CITY OF LAS VEGAS, NEVADA
 ENGINEERING DEPARTMENT
 PLAN AND PROFILE
 25 TH STREET WIDENING PROJECT

DESIGNED BY R.J.F.	DATE 5-3-66	PROJECT NUMBER 65-54
DRAWN BY C.S.	6-3-66	CONTRACT NUMBER CLV 255
CHECKED BY K.T.B.	8-1-66	DRAWING NUMBER CLV 20030
APPROVED BY

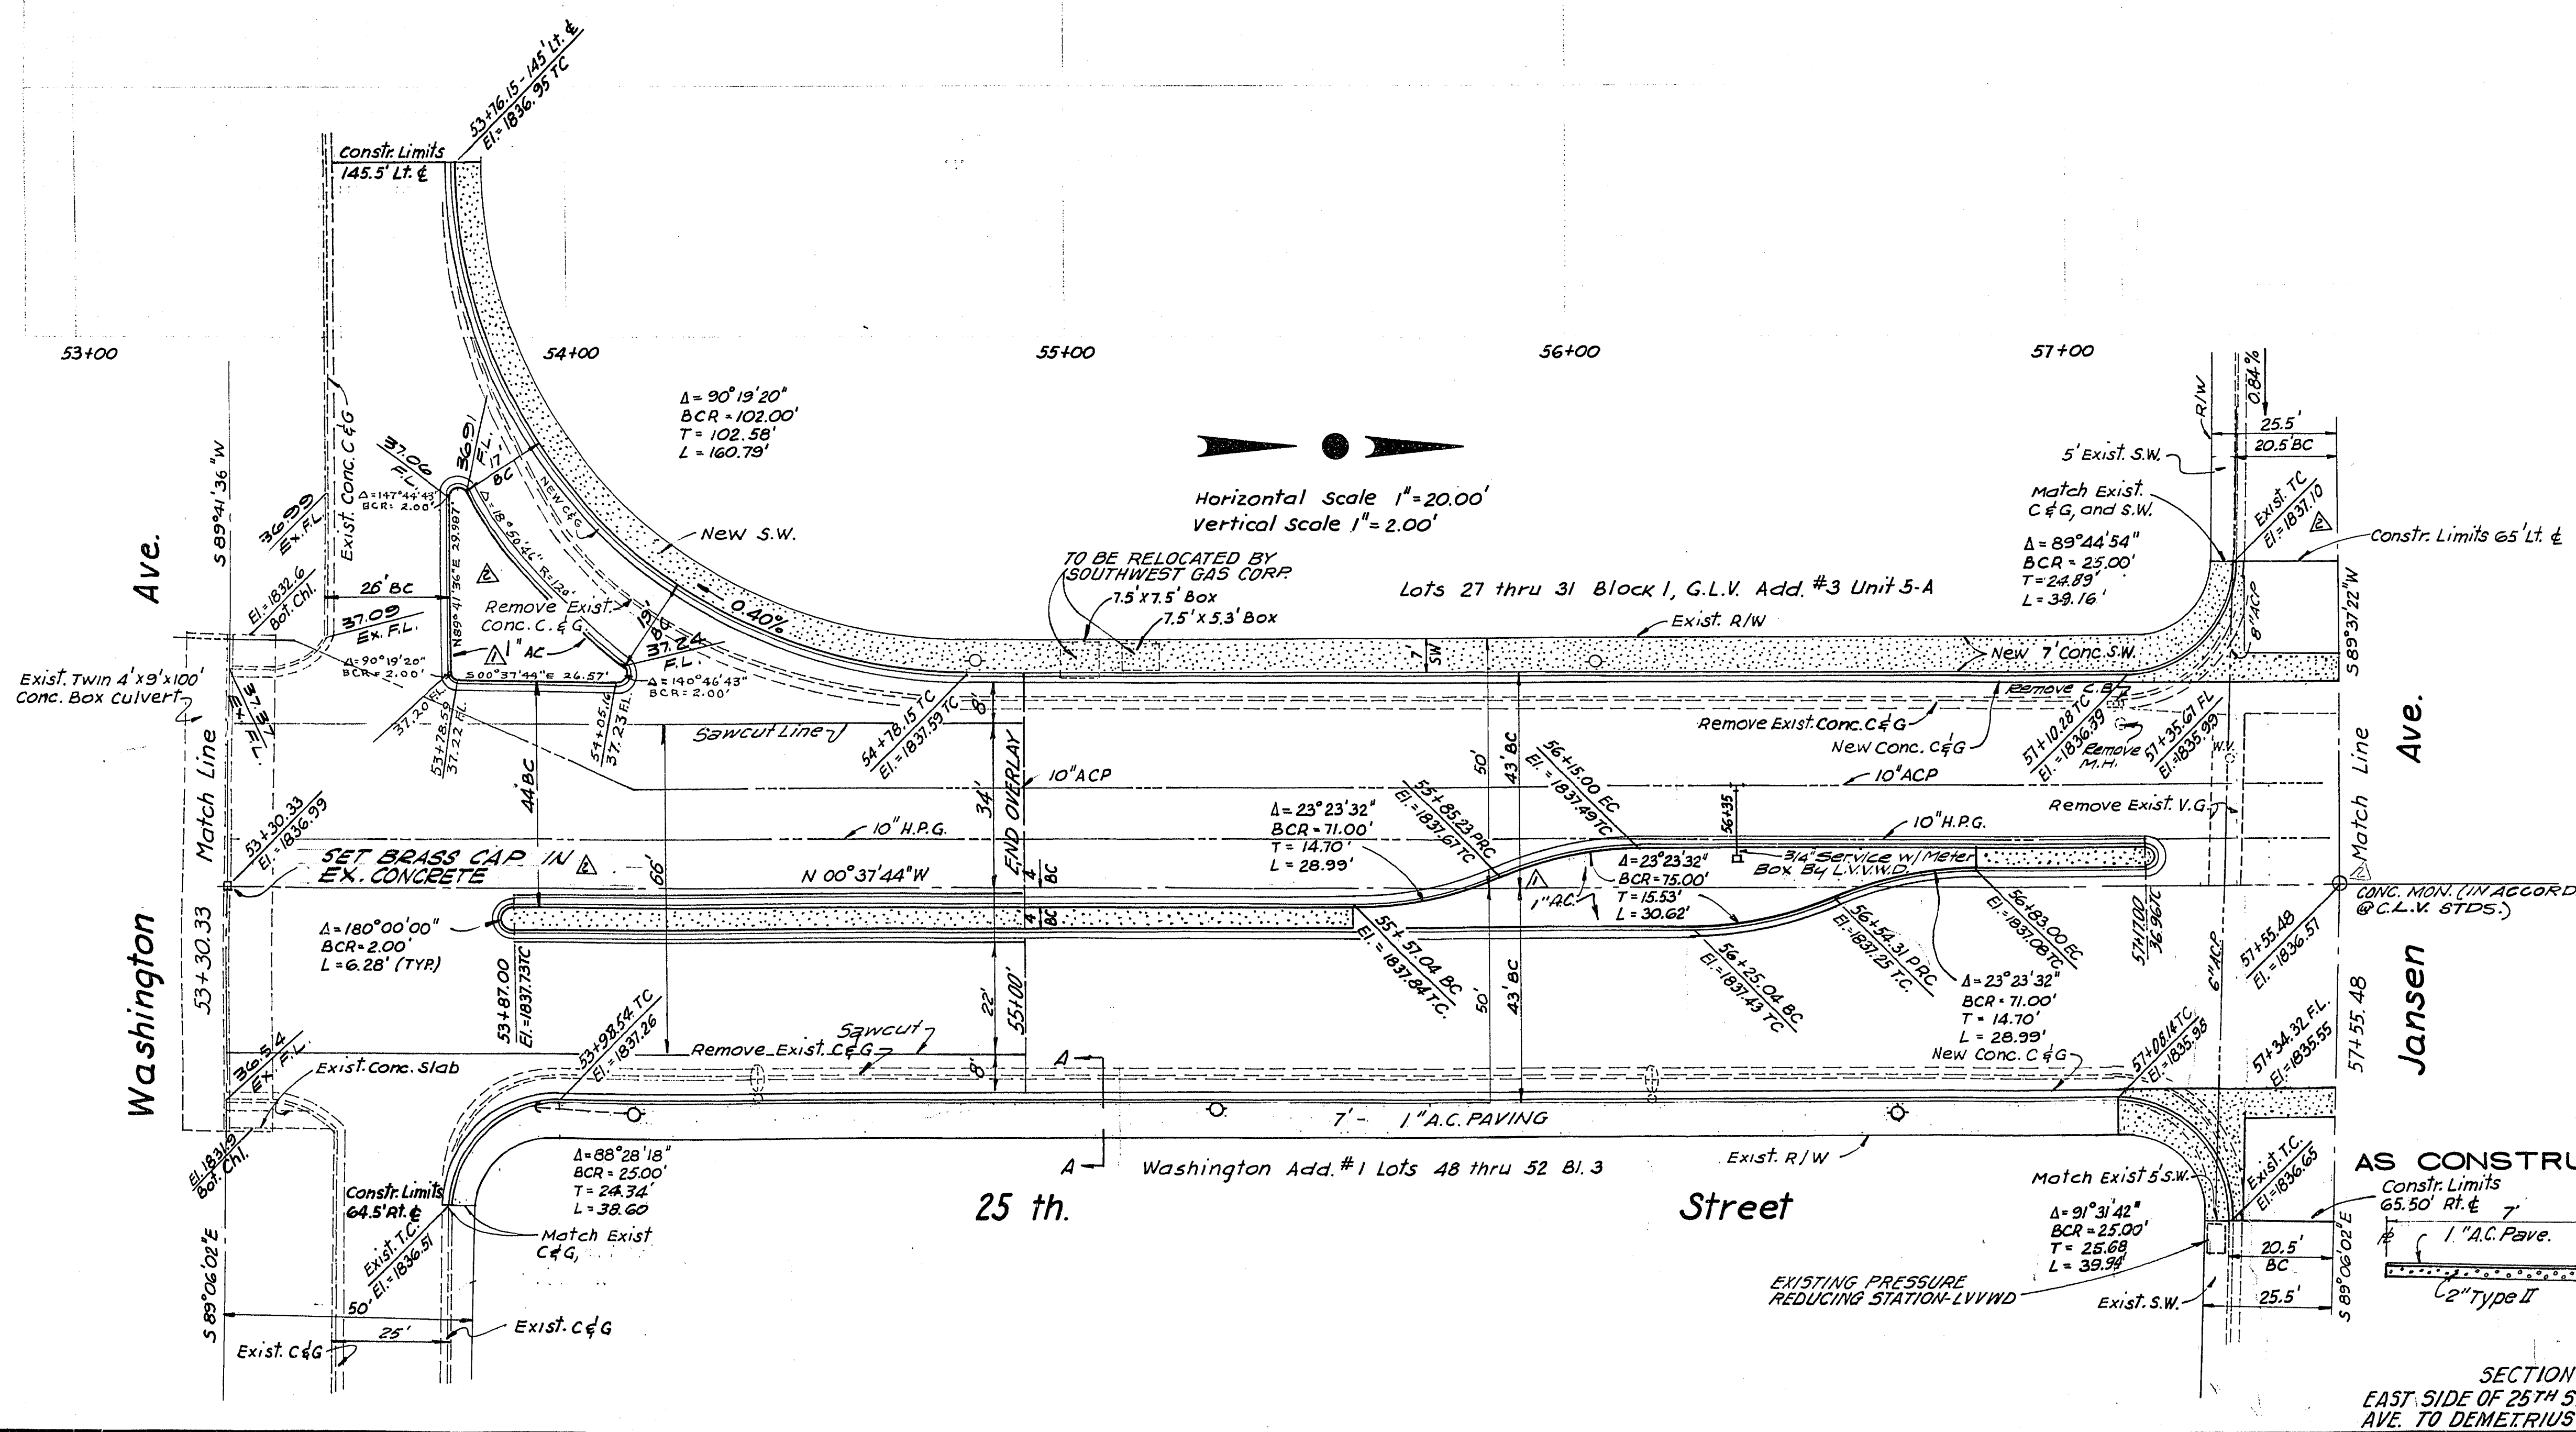
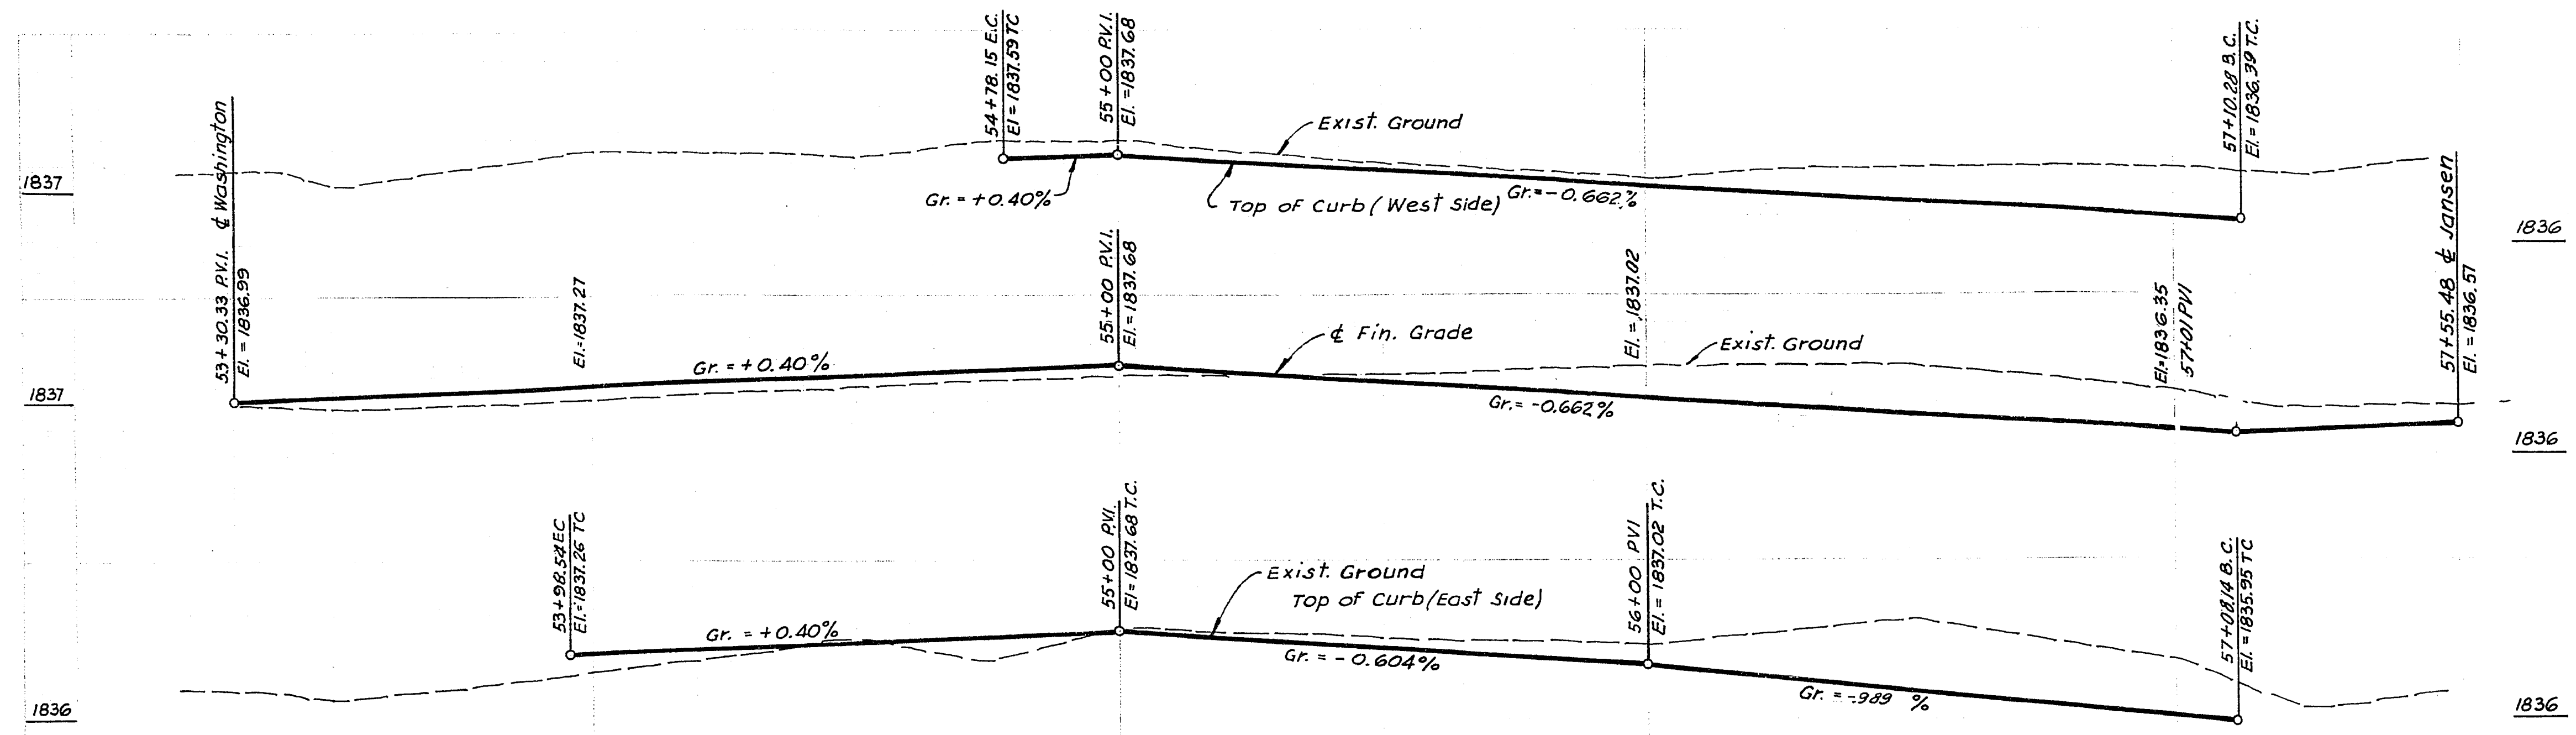
Change Order No. 1 Eliminate Items 9, 10 Added Item 35, D-10
 Traffic Island on NW cor. of Washington & 25th, changed T.C. elev.
 @ SW cor. of Jansen & 25th from 1837.75 to 1837.10
 Addendum No. 1 1" A.C. Pave on Island instead of 1/2"
